Addendum No.: Addendum No. 2

Project: Rio Rancho Elementary School – HVAC Upgrades
4601 PEPE ORTIZ RD. SE
Rio Rancho, New Mexico 87124

Project No.: 083340-15-002

Attachment – Sketch – SKM-001

C5 **ROOF TOP UNIT STRUCTURAL BASE - ANNEX BLDG.**
 SCALE = NONE

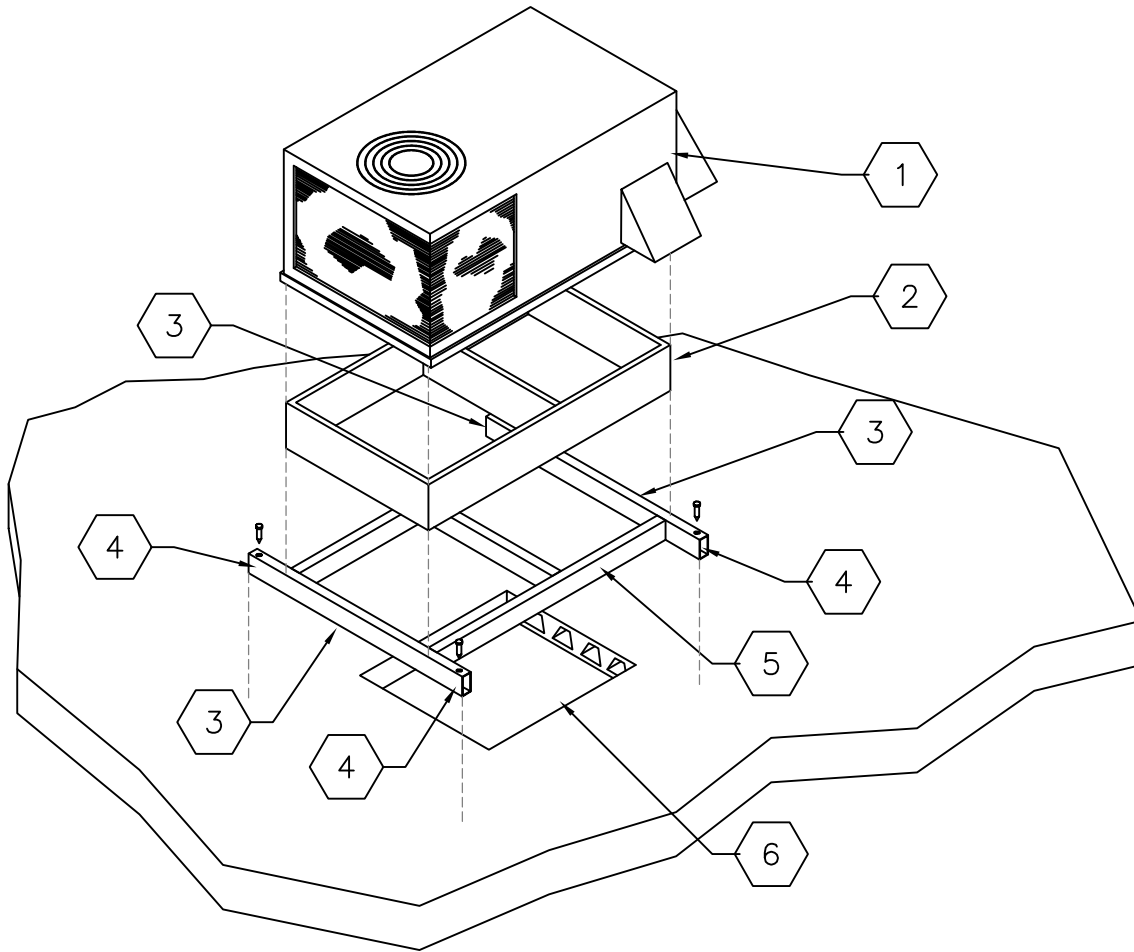
2.1. **ADD** – The packaged roof top units to be installed on the classroom annex building shall include an additional structural support base as noted in the attached sketch SKM-001. This base is intended to span and spread the unit weight across a slightly larger roof area than the standard factory roof curb. This work shall be included in the Bid Lot #2 bid cost. The roof top unit's and factory roof curbs shall be installed on top the fabricated tube steel base installed between the roof deck and roof curb as indicated on the sketch.

4.2.1. Add detail C5 Roof Top Unit Structural Base-Annex Bldg. indicated on attached sketch SKM-001.

- 1 INSTALL & ANCHOR NEW ROOF TOP UNIT ON FACTORY CURB.
- 2 FACTORY ROOF CURB—ANCHOR TO FIELD FABRICATED STRUCTURAL BASE.
- 3 STRUCTURAL BASE— FABRICATE FROM WELDED 3"X6" TUBE STEEL. DIMENSIONS SHALL MATCH ROOF TOP UNIT CURB DIMENSION SO THAT ROOF CURB IS FULLY SUPPORTED. END MEMBERS SHALL BE 24" WIDER THAN WIDTH OF ROOF CURB SO MIN OF 12" OF MEMBER EXTENDS BEYOND EACH SIDE OF UNIT. ANCHOR BASE TO ROOF DECK PER BID LOT#1 ARCHITECT.
- 4 THIS END OF MEMBER TO EXTEND 12" BEYOND SIDE OF ROOF CURB.
- 5 ROOFING CONTRACTOR SHALL INFILL RIGID INSULATION AROUND STRUCTURAL BASE AND ROOF CURB TO THICKNESS SPECIFIED ON BID LOT#1 ARCHITECTURAL PLANS.
- 6 EXISTING ROOF OPENING WHERE SKYLIGHT WAS REMOVED.
